DC-9

REFERENCE:
BULLETIN 24-69

SUBJECT: ELECTRICAL POWER - Electrical Load Distribution - Replace Lavatory Flush Pump Motor Circuit Breakers.

SERVICE BULLETIN

LAVATORY FLUSH PUMP MOTOR CIRCUIT BREAKER - REPLACEMENT

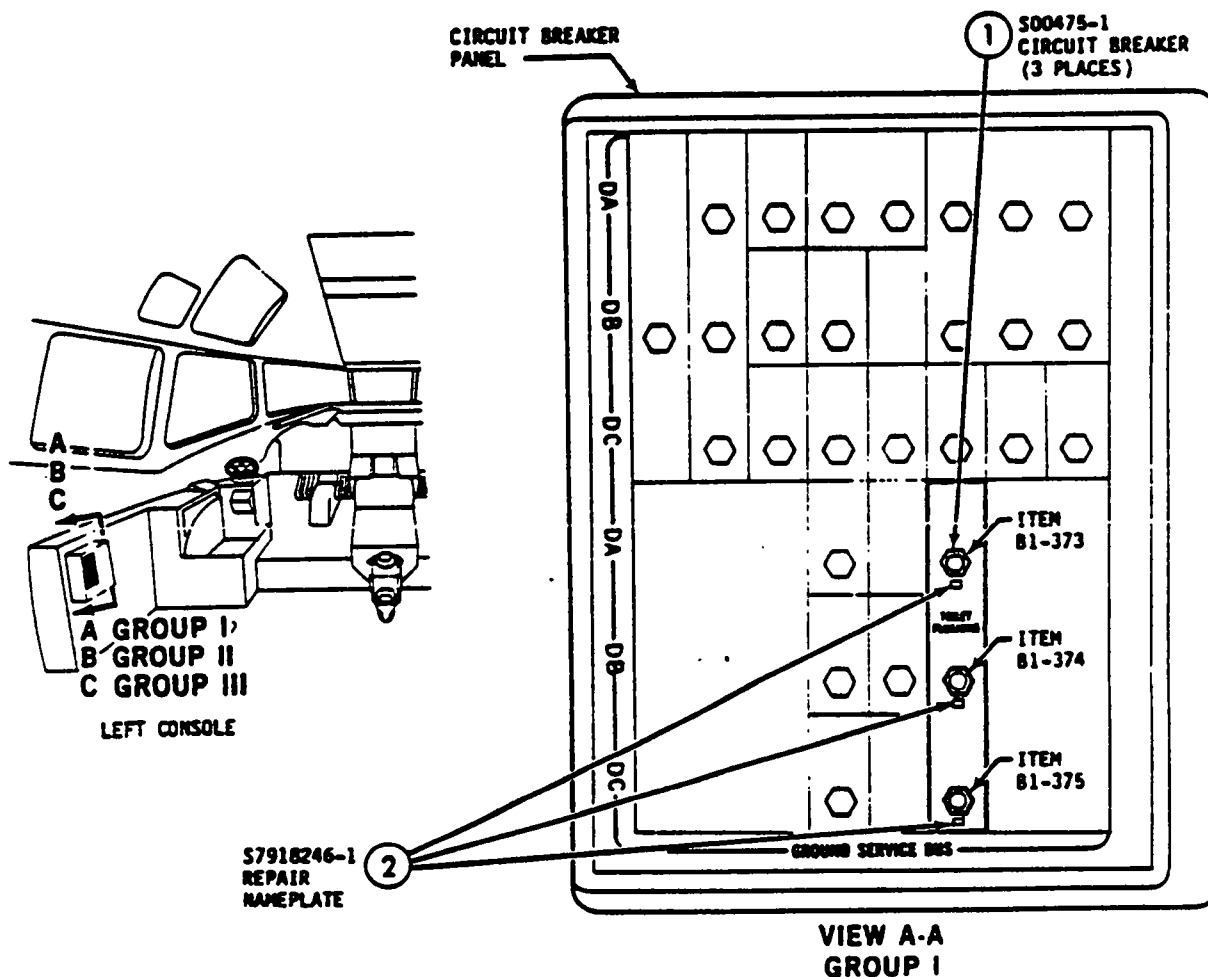
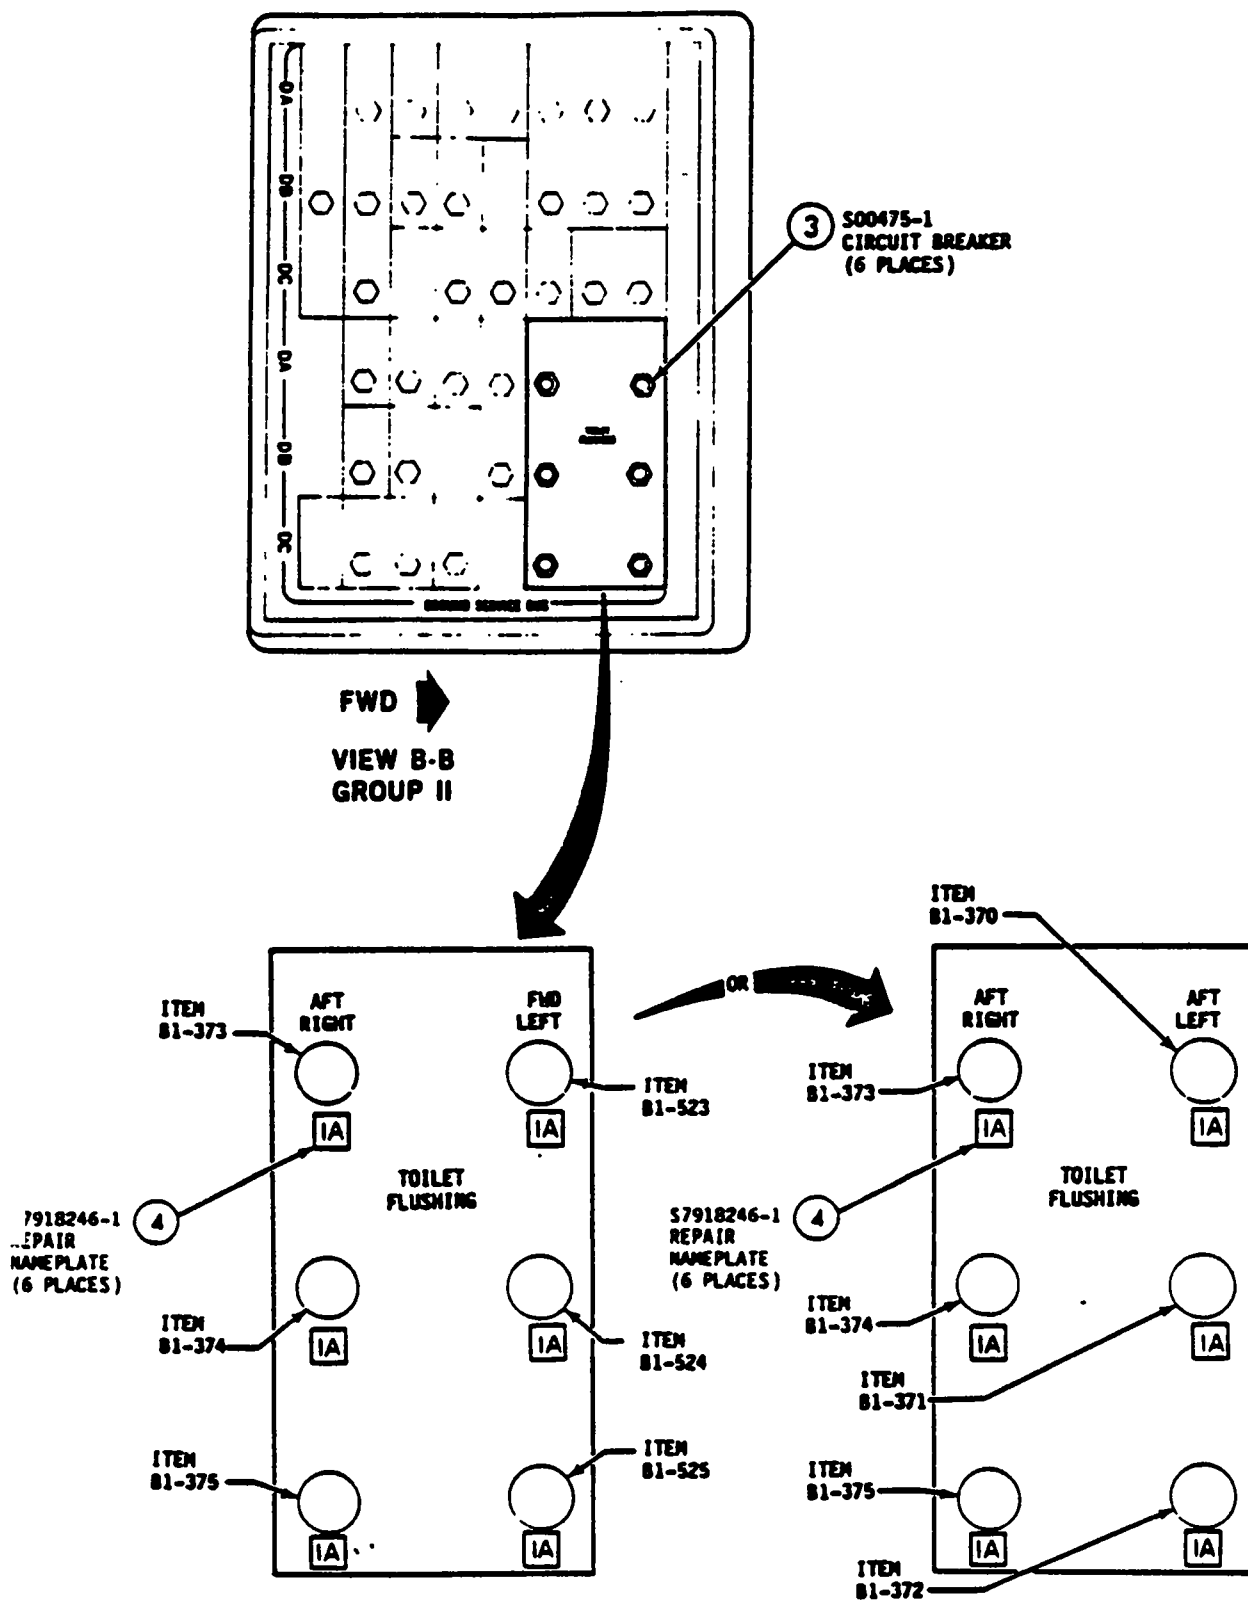
- ① REPLACE 7274-55-5 CIRCUIT BREAKERS (ITEMS 81-373, 81-374, AND 81-375) WITH S00475-1 CIRCUIT BREAKERS.
- ② INSTALL THREE S7918246-1 REPAIR NAMEPLATES.

- ③ REPLACE 7274-55-5 CIRCUIT BREAKERS (ITEMS 81-373, 81-523, 81-374, 81-524, 81-375, AND 81-525) WITH S00475-1 CIRCUIT BREAKERS.

REPLACE 7274-55-5 CIRCUIT BREAKERS (ITEMS 81-373, 81-370, 81-374, 81-371, 81-375, AND 81-372) WITH S00475-1 CIRCUIT BREAKERS.

- ④ INSTALL SIX S7918246-1 REPAIR NAMEPLATES.

- ⑤ REPLACE 7274-55-5 CIRCUIT BREAKERS (ITEMS 81-373, 81-370, 81-523, 81-374, 81-371, 81-524, 81-375, 81-372, AND 81-525) WITH S00475-1 CIRCUIT BREAKERS.
- ⑥ INSTALL NINE S7918246-1 REPAIR NAMEPLATES.

LAVATORY FLUSH PUMP MOTOR CIRCUIT BREAKER - REPLACEMENT

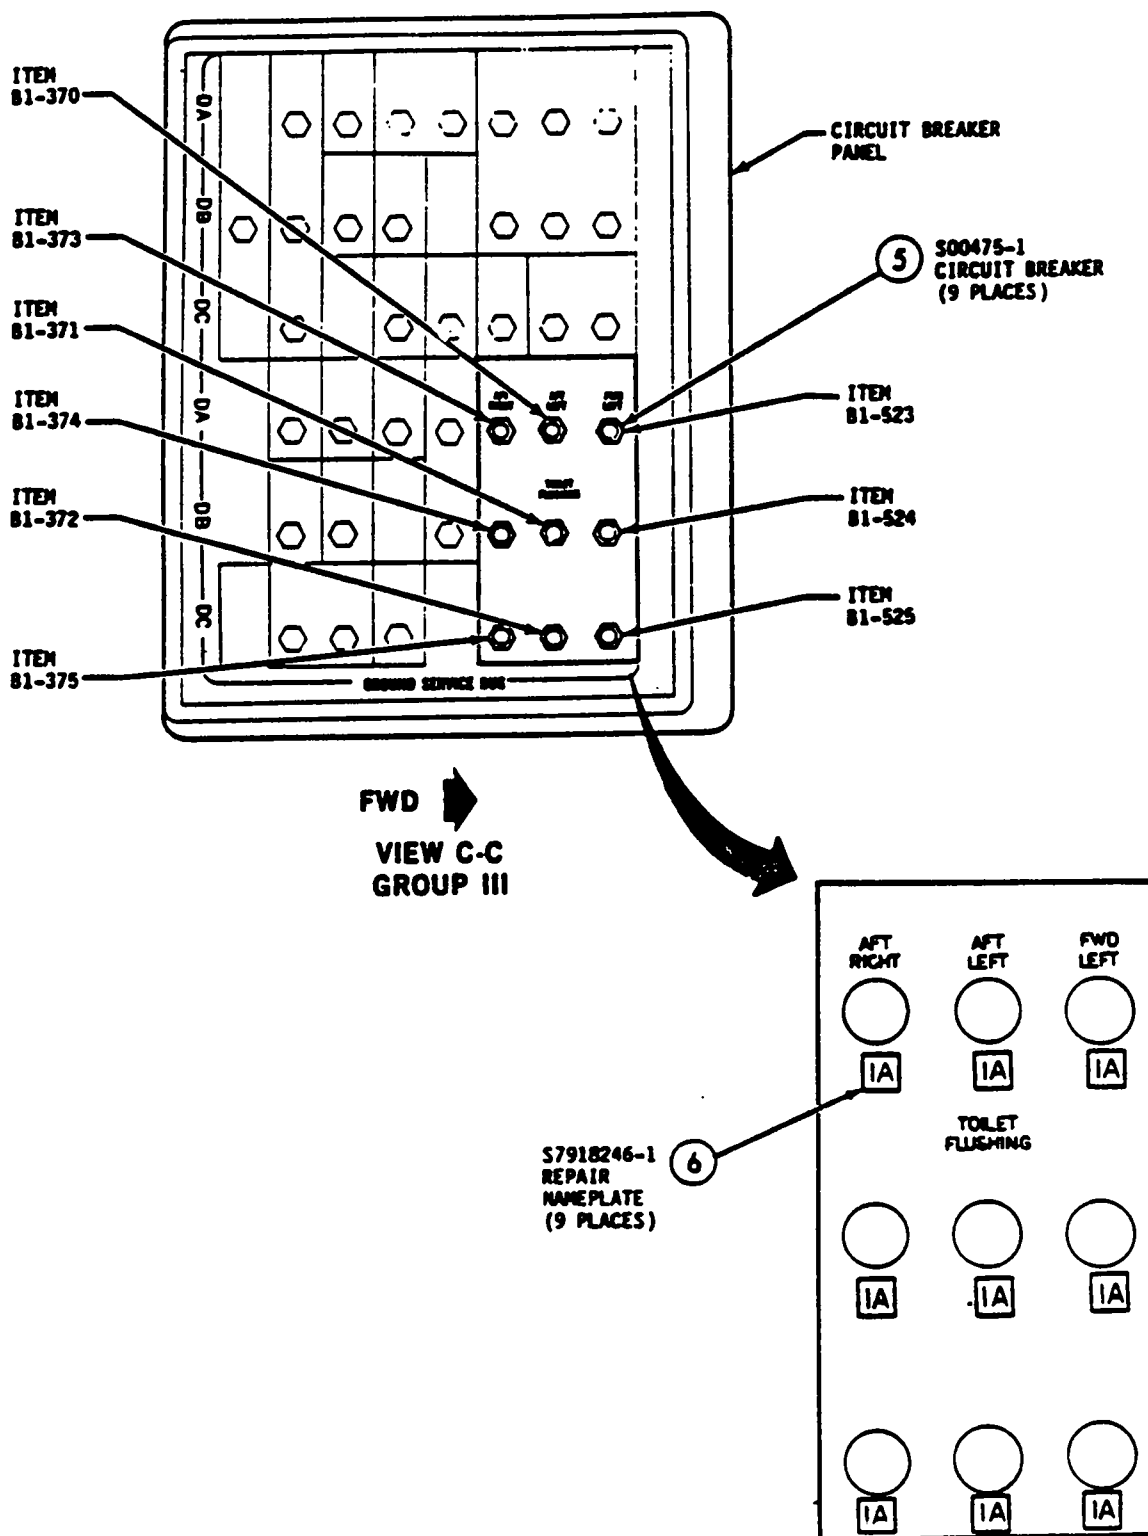
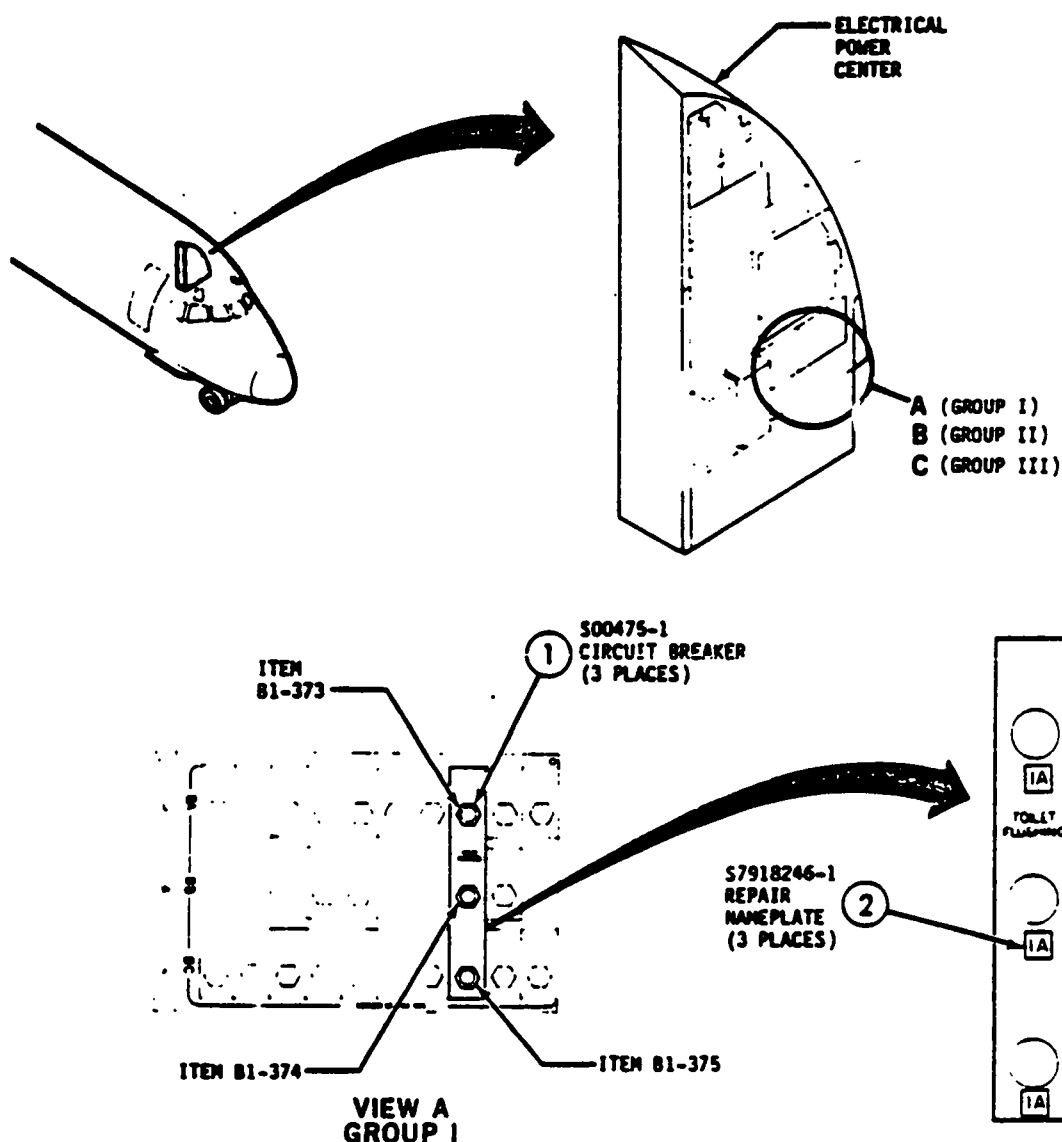
- ① REPLACE 7274-55-5 CIRCUIT BREAKERS (ITEMS 81-373, 81-374, AND 81-375) WITH S00475-1 CIRCUIT BREAKERS.
- ② INSTALL THREE S7918246-1 REPAIR NAMEPLATES.

- ③ REPLACE 7274-55-5 CIRCUIT BREAKERS (ITEMS 81-373, 81-370, 81-374, 81-371, 81-375, AND 81-372) WITH S00475-1 CIRCUIT BREAKERS.
- ④ INSTALL SIX S7918246-1 REPAIR NAMEPLATES.

- ⑤ REPLACE 7274-55-5 CIRCUIT BREAKERS (ITEMS 81-373, 81-370, 81-523, 81-374, 81-371, 81-524, 81-375, 81-372, AND 81-525) WITH S00475-1 CIRCUIT BREAKERS.
- ⑥ INSTALL NINE S7918246-1 REPAIR NAMEPLATES.

**VIEW C
GROUP III**

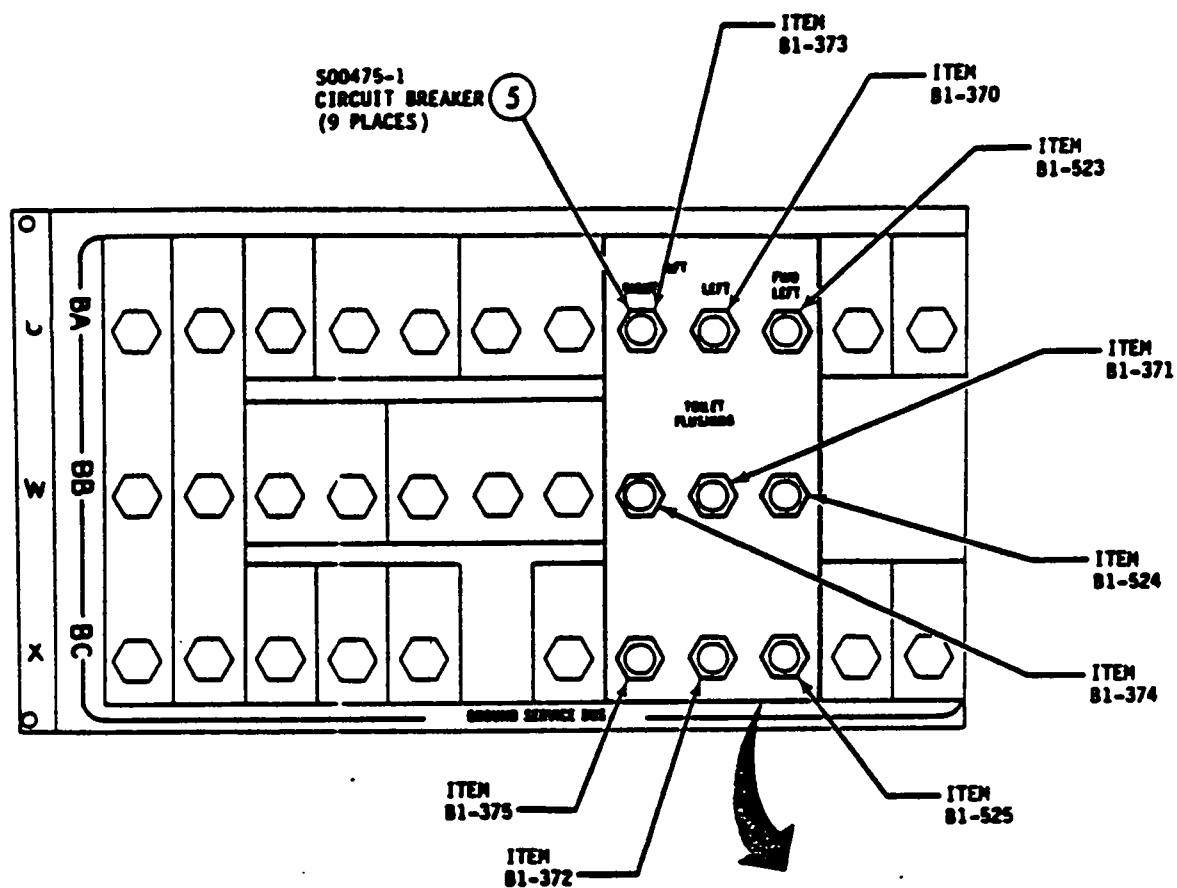
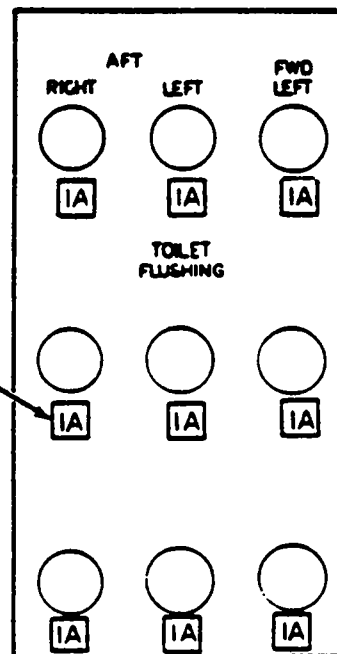
S7918246-1
 REPAIR
 NAMEPLATES
 (9 PLACES)
